File Number: ACS2020-PIE-PS-0082

SUBJECT: Zoning By-law Amendment – 339-343 Gloucester Street

This report recommends that Council approve an amendment to Zoning By-law 2008-250 for 339-343 Gloucester Street. The amendments will facilitate the demolition of the existing two-and-a-half-storey townhouse and construction of a new 21-storey apartment building with 115 dwelling units.

Document 4 – Proposed site plan

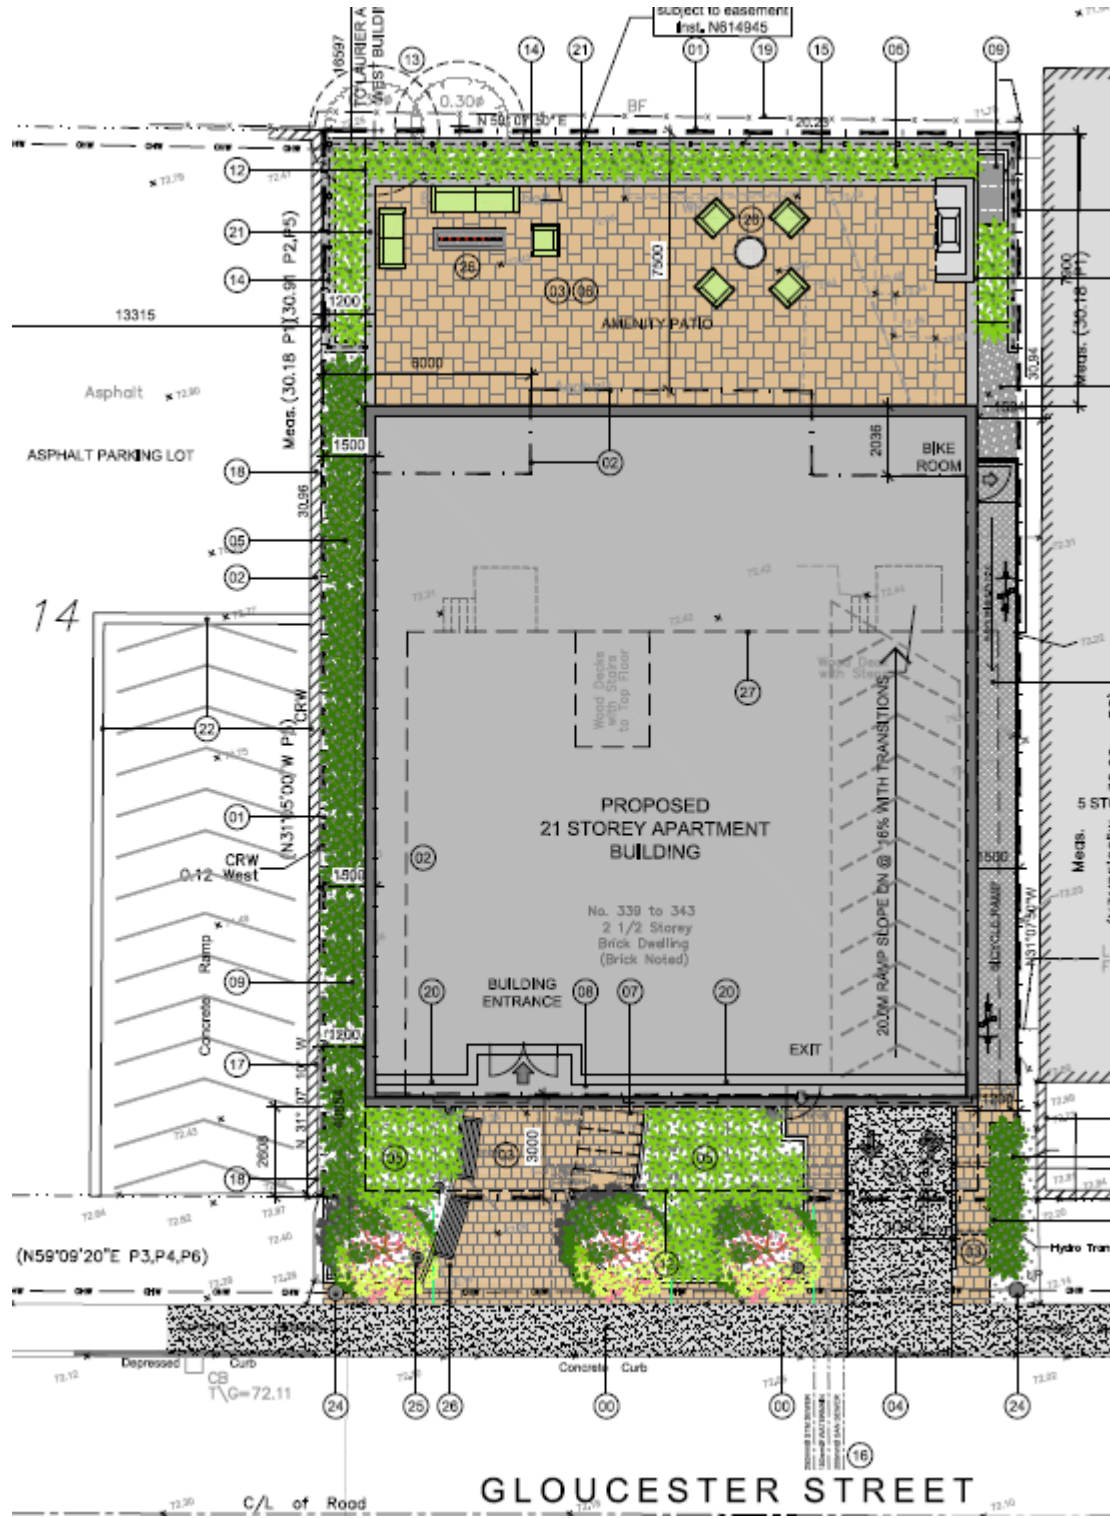
- The Panel expressed serious concerns with the scale of the proposed building and the poor relationship that it establishes with adjacent properties. In the event that the neighbouring properties should redevelop with a similar typology, the result would be narrow tower separation distances that would result in poor living conditions.
- It is recommended that the proposal demonstrate greater adherence to the City's high-rise guidelines or secure legal agreements with neighboring properties to ensure adequate separation distances will be achieved in the future.

- The base of the building appears too squat and lacks presence at the street level. Explore means of strengthening its expression as more of a true podium, perhaps by increasing its height to two storeys.

- Achieving the desired effect of the “pinwheel” design will be dependent on creating a change in planes between the two tones. A minimum 1.0-metre pane change is recommended.

- It is recommended that the location of the balconies be adjusted, so that the underside of the balconies and the edge of the pinwheel planes are not aligned. The boarder of the pinwheel should be visible all around its edge.
